DESCRIPTION OF REQUEST: Proposed Lot Split

Re: 509 – 511 High St. SE Request for Sketch Plat Review

PA # 14-073 **DATE: 5/27/14** **TIME: 1:30**
Applicant: Terry O. Brown
Site Address: 509-511 High St. SE
Acreage: .1631
Zoning: SU-2 for LCR
Zone Atlas Page K-14
Applicable Plans: South Broadway and Huning Highland HOZ
Request: Subdivide existing lot 7 build 2 residential units on each of the 2 new lots

Site Plan

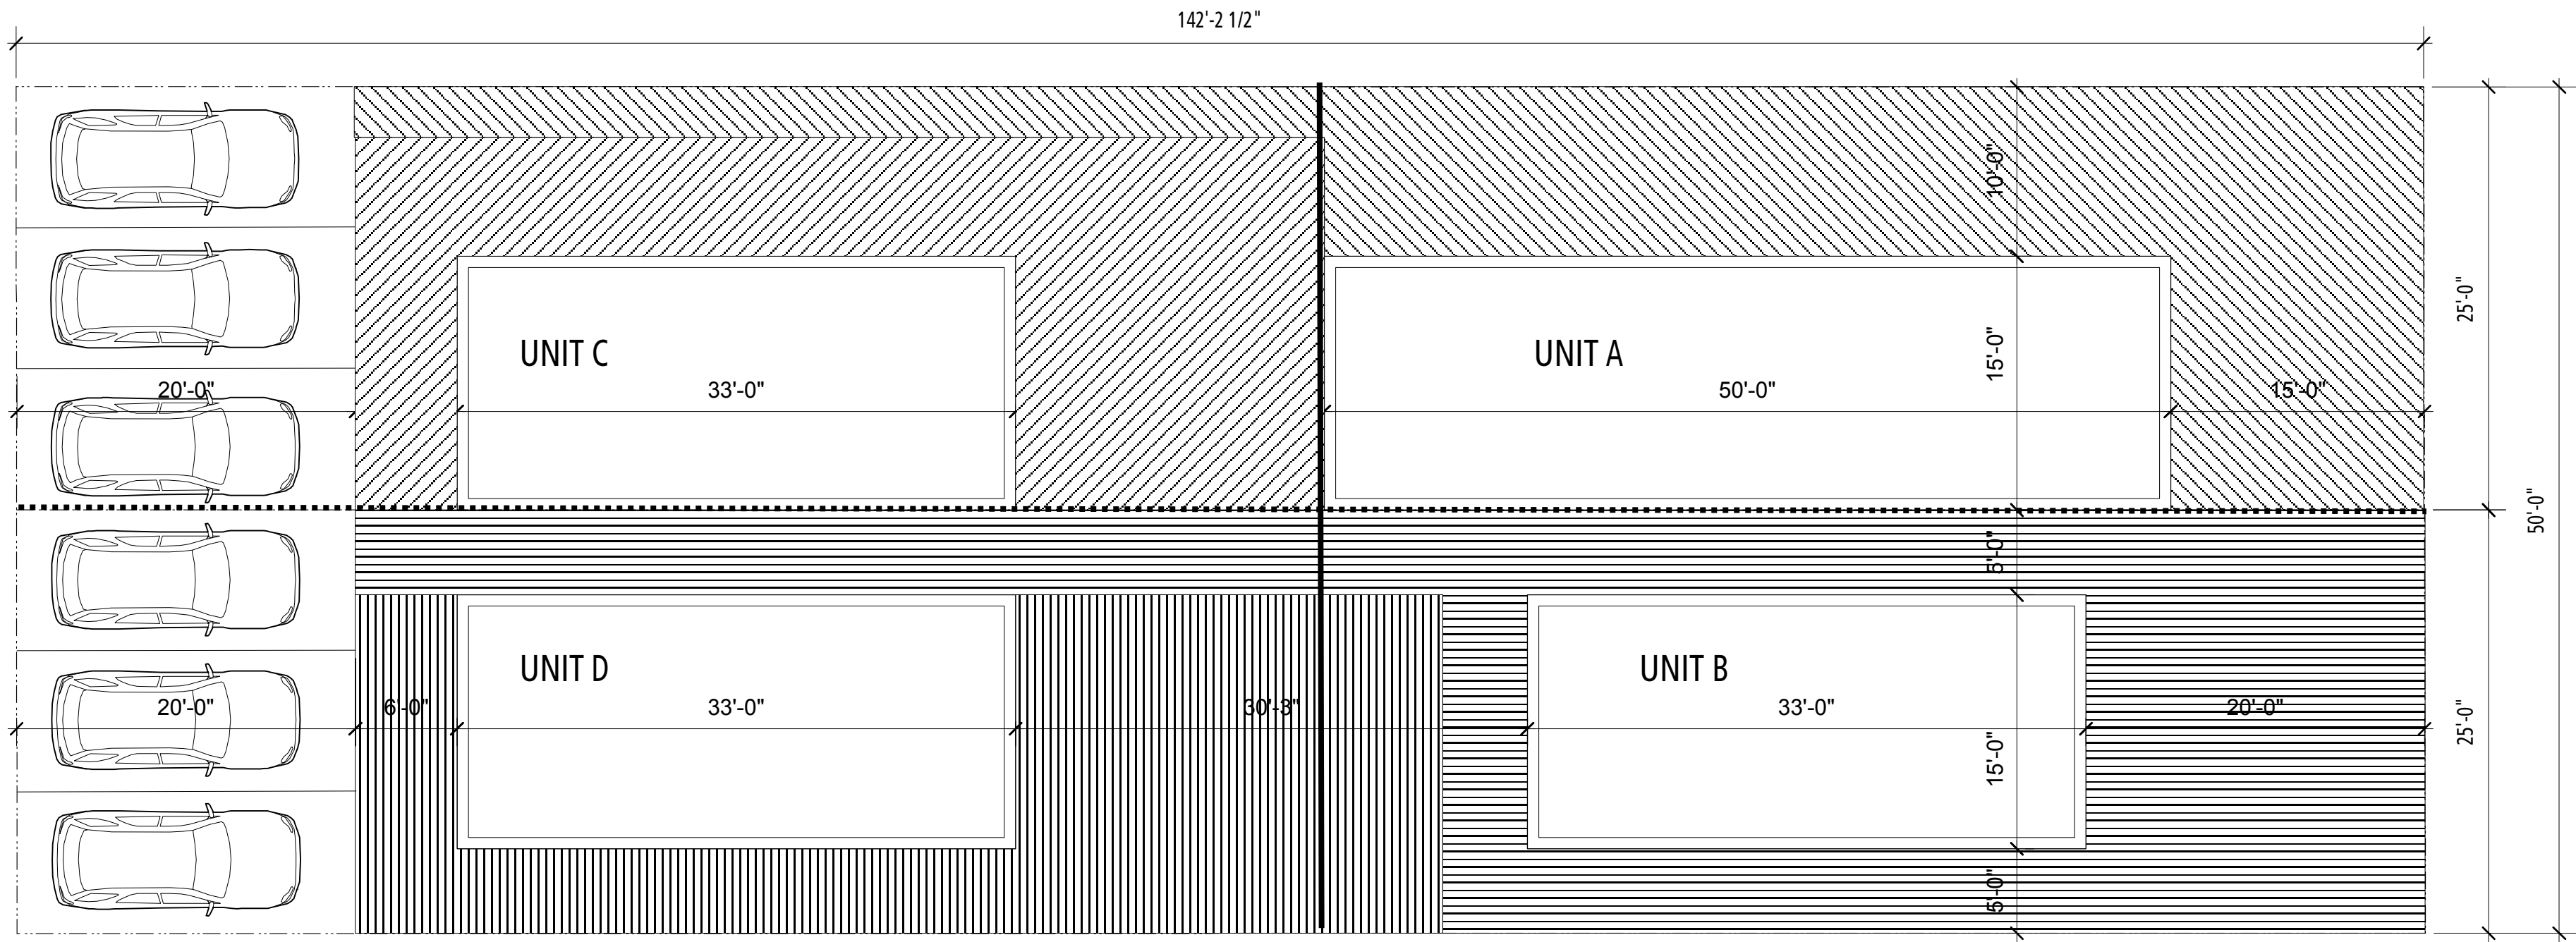
Staff questions note on site plan regarding proposed lot #2 and zone change to MR.
